Item ID: D2580-1 Accept *N900040100* Setup Start *NS1*
 Revision ID: Stop *NS2*
 Item Name: 205 Skidtube bent detail
 Start Date: 25/01/2012 Start Qty: 2.00 *2* Cust Item ID:
 Required Date: 27/01/2012 Req'd Qty: 2.00 *2* Customer:
 Reference:

DRAWING NO. D2580	TITLE 205 SKIDTUBE ASSEMBLY	REV. E	DART AEROSPACE LTD ENGINEERING ORDER	D.E.O. NO. D2580-E-1	SHEET NO. SHEET 1 OF 1	SCALE NTS
DRAWN <i>UP</i>	CHECKED <i>ASS</i>	MFG. APPR. <i>EC</i>	APPROVED <i>HA</i>	DE APPR. <i>HA</i>		
DATE 11.12.13	DATE 11.12.13	DATE 11.12.13	DATE 11.12.13	DATE 11.12.13	DATE 11.12.13

CHANGE ALL C'BORED WELDED CROSSBOLT SPACERS TO SWAGED SPACERS

SECTION B-B
SCALE 5X

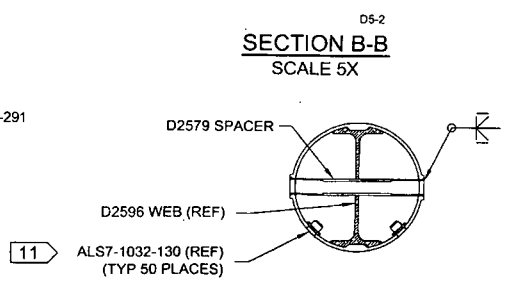
- AFTER DRILLING AND BENDING ASSEMBLY
PERFORM THE FOLLOWING FOR Ø0.508 HOLES ONLY:
1. CHAMFER HOLE 0.050 X 45°
 2. INSERT D2579 SPACER (20 PLACES)
 3. WELD INTO PLACE AND GRIND FLUSH
 4. C'BORE D2579 SPACER TO Ø0.437 X 1.00 DEEP

SECTION B-B, SECTION F-F, & SECTION I-I ARE AMENDED AS FOLLOWS
FOR ALL HOLES THAT WERE ORIGINALLY C'BORED:

1. INSERT D4202-1 SPACER, 20 PL (-041) OR 20 PL (-045) OR 25 PL (-047)
2. SWAGE TO Ø0.437 X 1.00 DEEP PER QSI 002
3. TRIM / GRIND FLUSH PER QSI 002

SECTION F-F
SCALE 5X

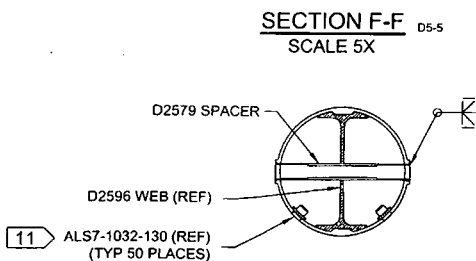
- AFTER DRILLING AND BENDING ASSEMBLY
PERFORM THE FOLLOWING FOR Ø0.508 HOLES ONLY:
1. CHAMFER HOLE 0.050 X 45°
 2. INSERT D2579 SPACER (24 PLACES)
 3. WELD INTO PLACE AND GRIND FLUSH
 4. C'BORE D2579 SPACER TO Ø0.437 X 1.00 DEEP

*** FOR -045 SKIDTUBE ONLY:**
WELD 4X D2579 SPACERS PER DWG
IN LOCATIONS MARKED "NO C'BORE".
REF SHEET 4 OF DWG.

SECTION B-B, F-F, I-I
NOT TO SCALE

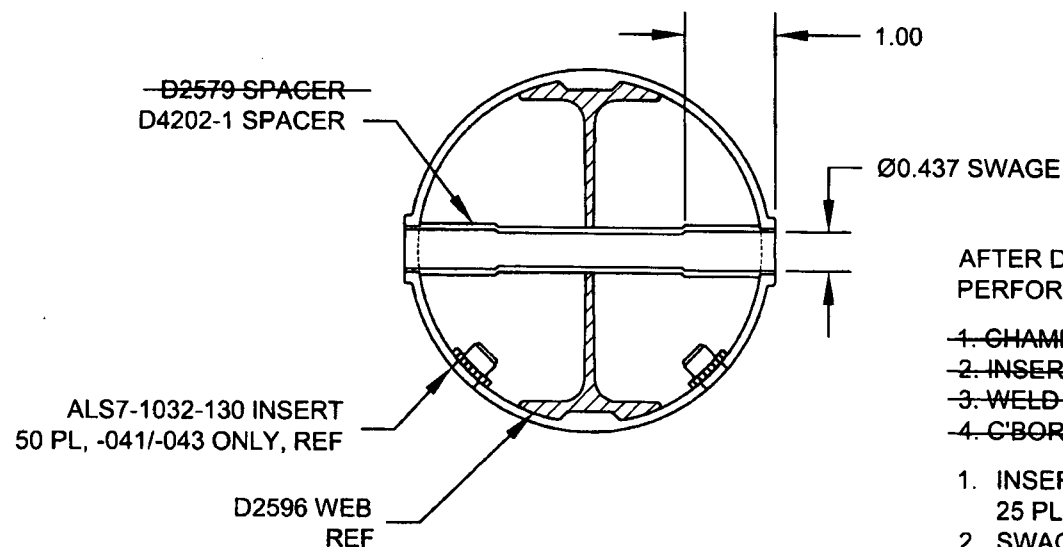
AFTER DRILLING AND BENDING ASSEMBLY
PERFORM THE FOLLOWING FOR Ø0.508 HOLES ONLY:

1. CHAMFER HOLE 0.050 X 45°
2. INSERT D2579 SPACER (20 PLACES)
3. WELD INTO PLACE AND GRIND FLUSH
4. C'BORE D2579 SPACER TO Ø0.437 X 1.00 DEEP
